CONSTRUCTION PLANS FOR

NOR ESTE MANOR SUBDIVISION

DRAINAGE, GRADING, PAVING AND UTILITY
IMPROVEMENTS

NOTE:
SHEETS AFFECTED BY CHANGE ORDER #1
AS INDICATED

DRAWING NO 3355 MAP NO C-19 SHEET 41 OF 52

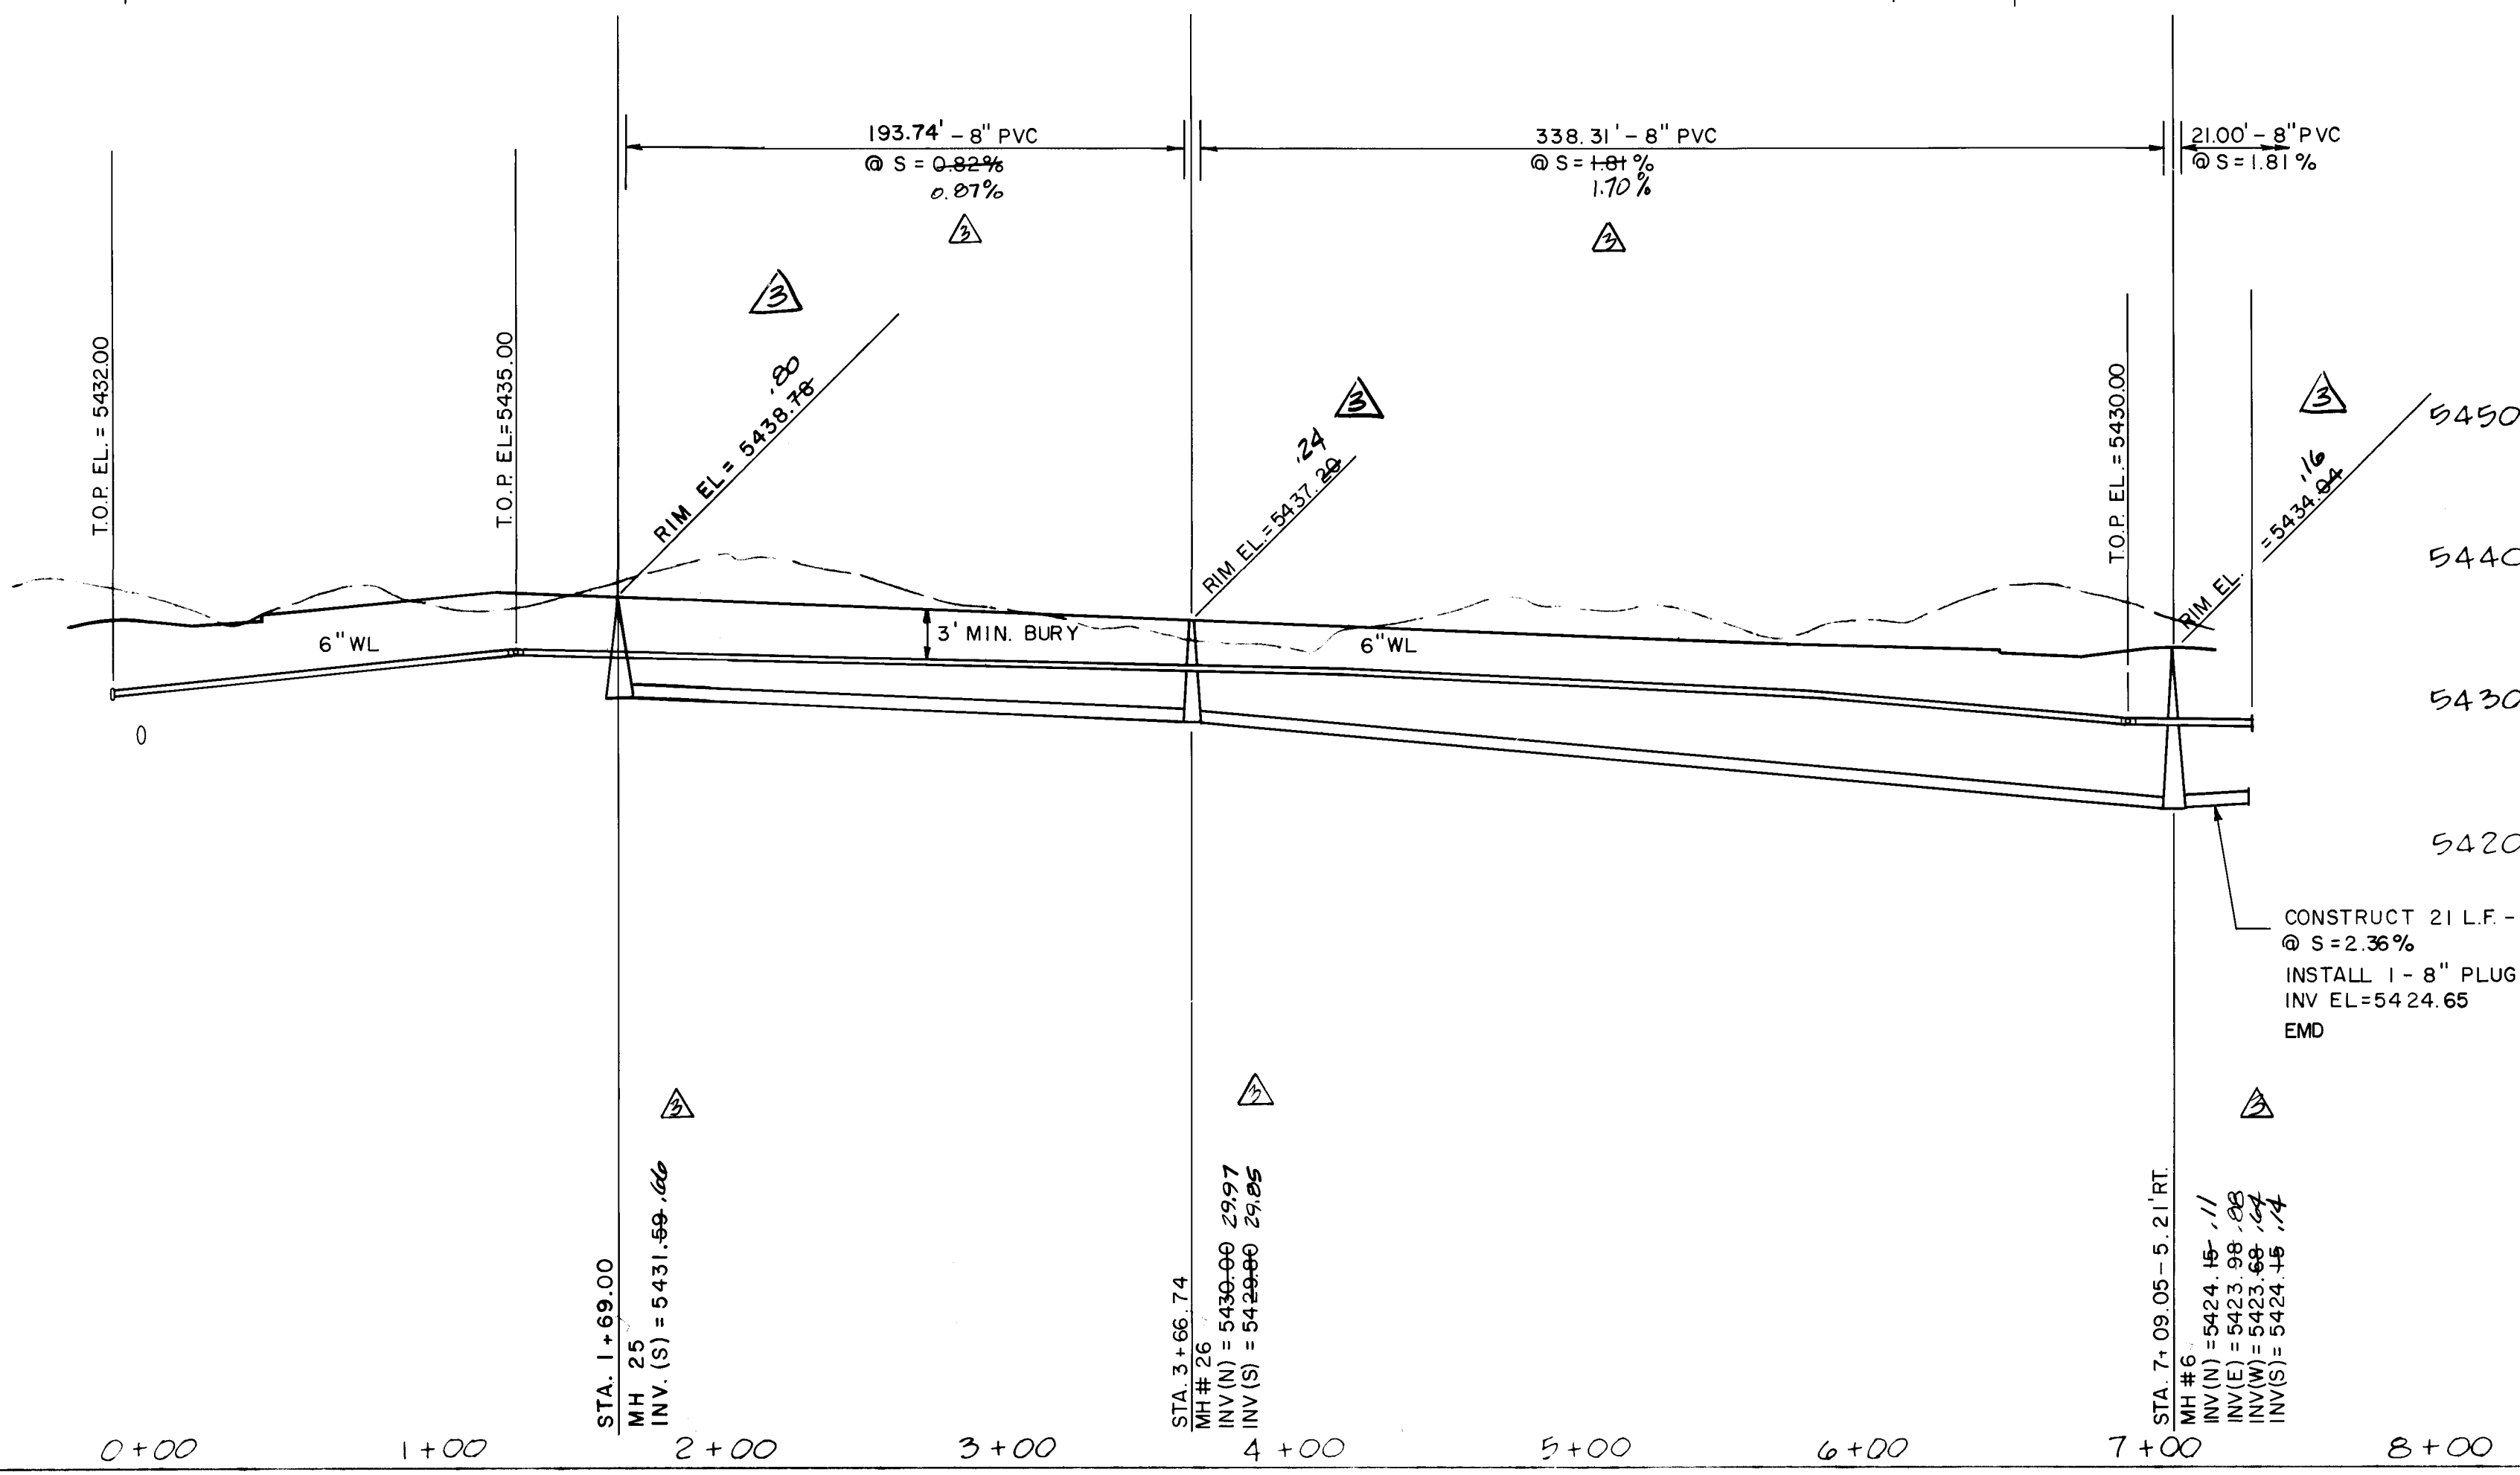
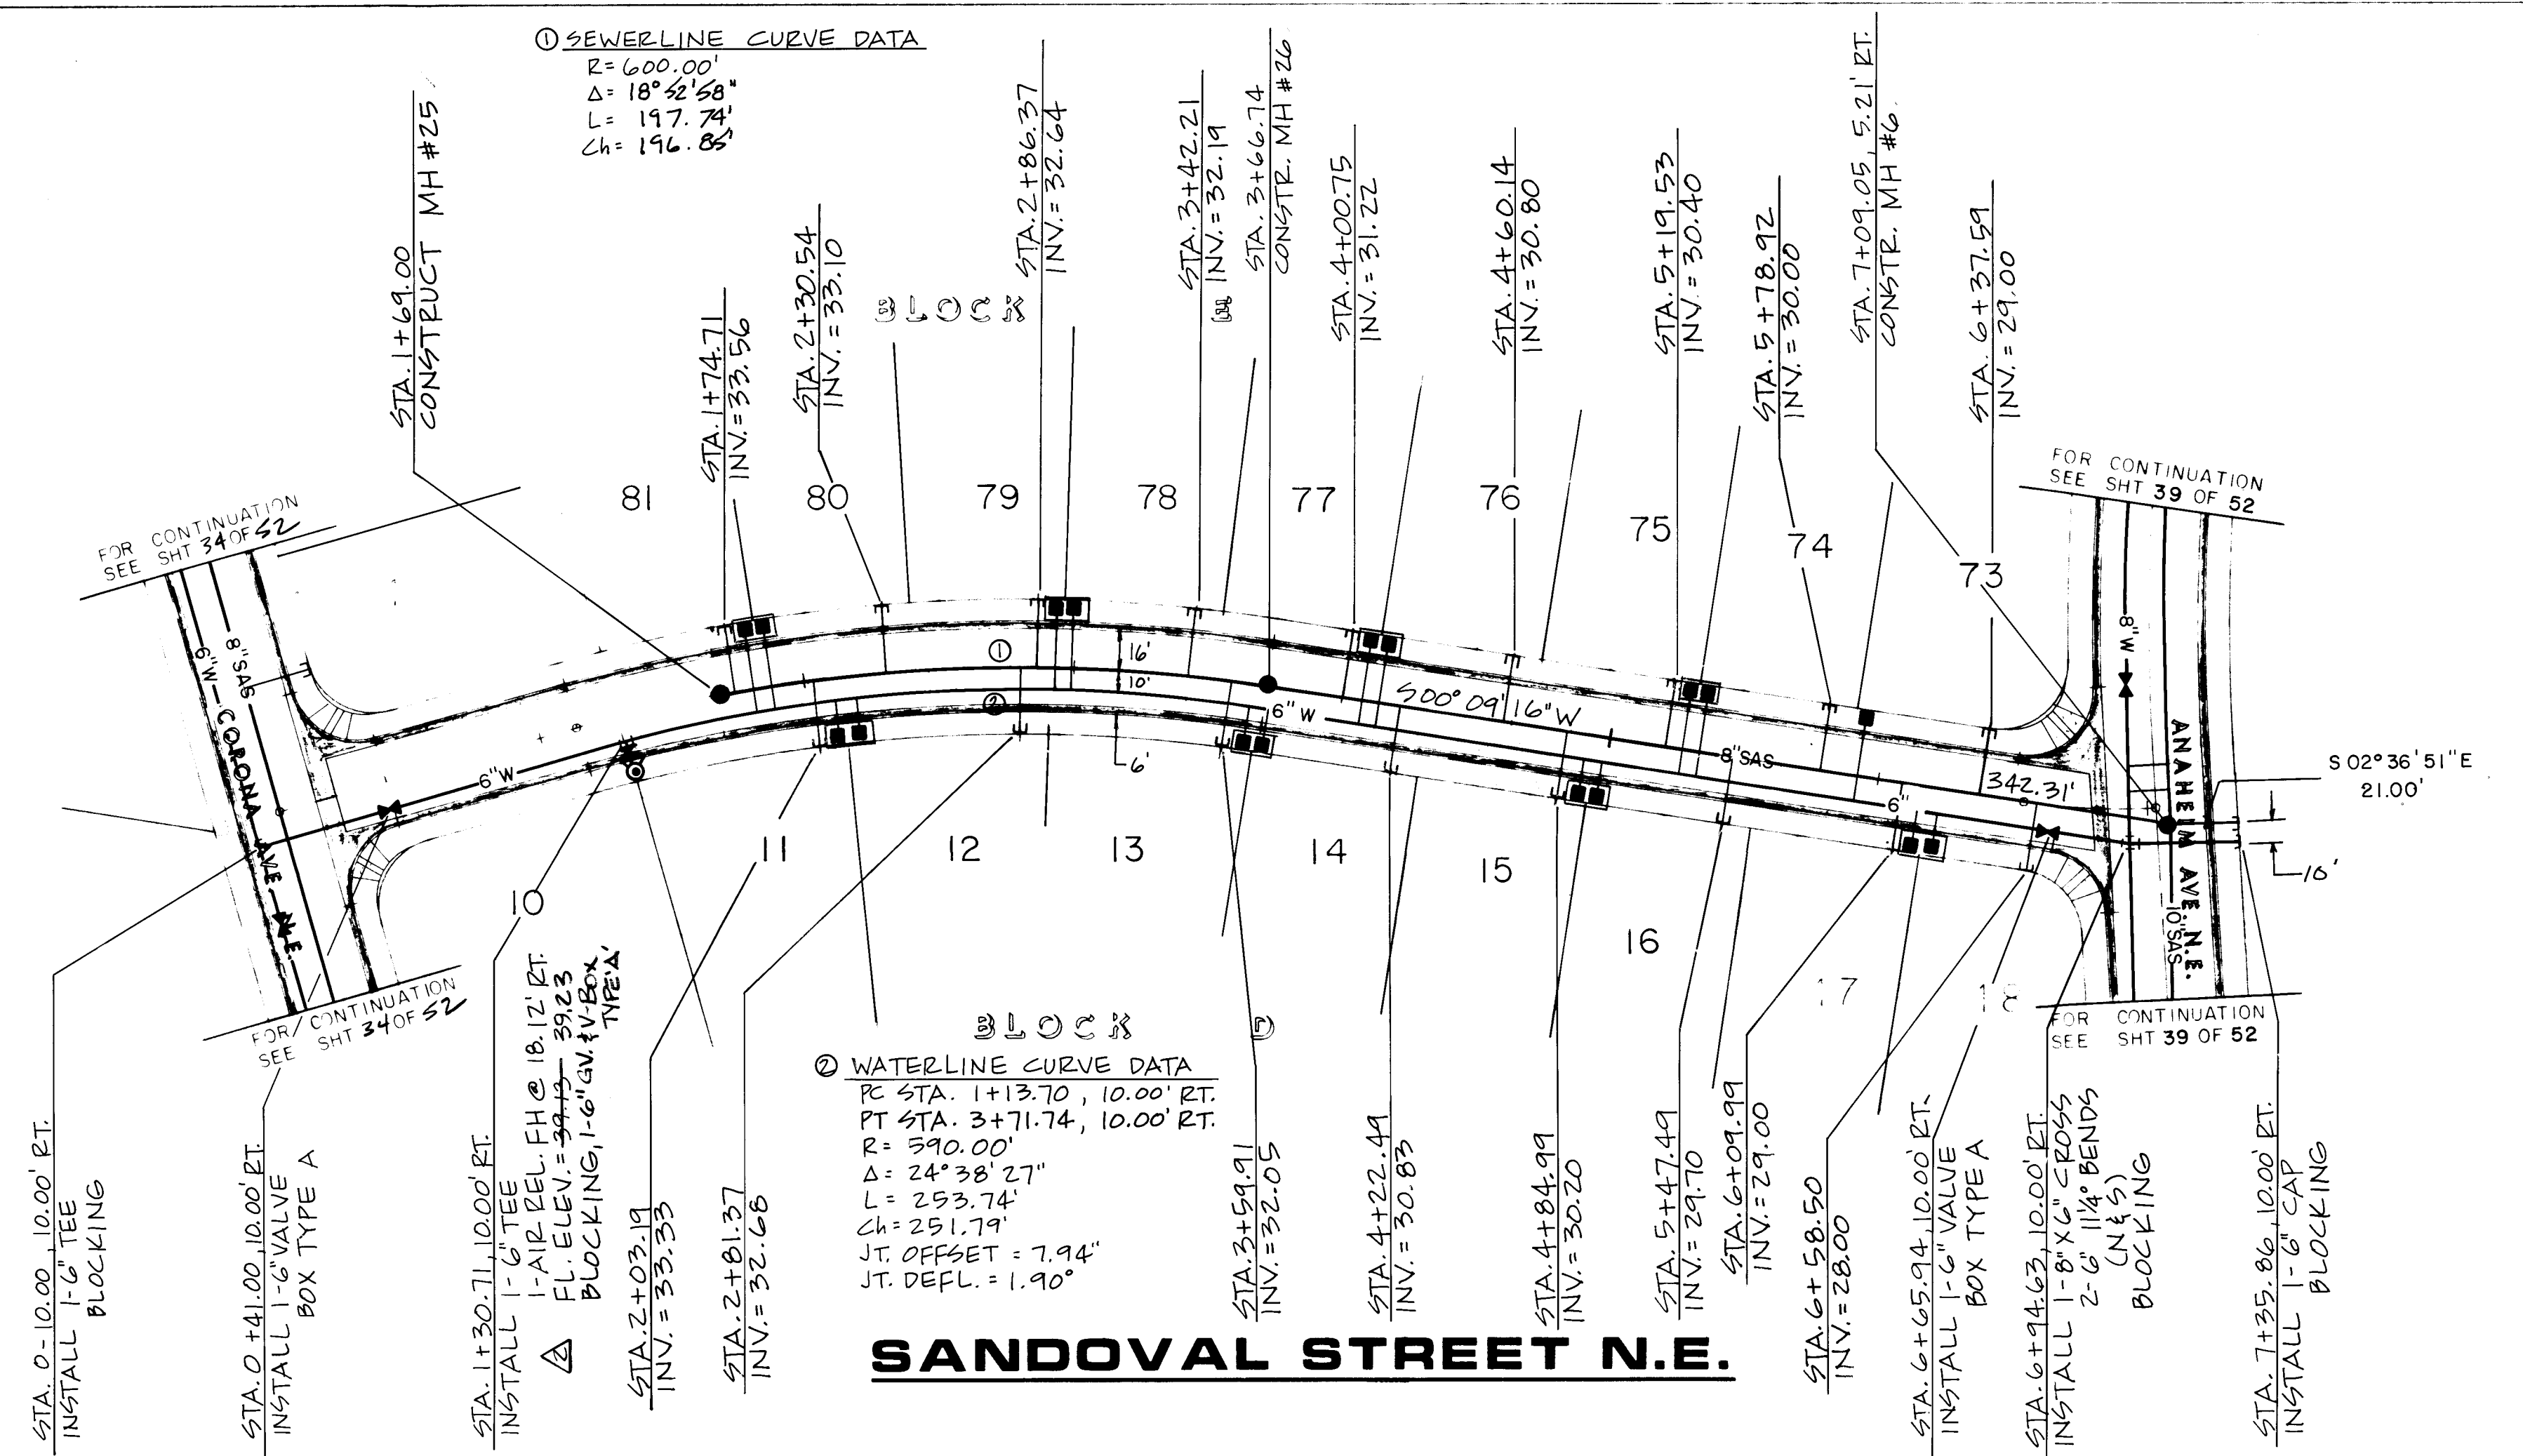
CHANGE ORDER NO. 1
REVISIONS
REVISE 8" STUBOUT GRADE AT ANAHEIM
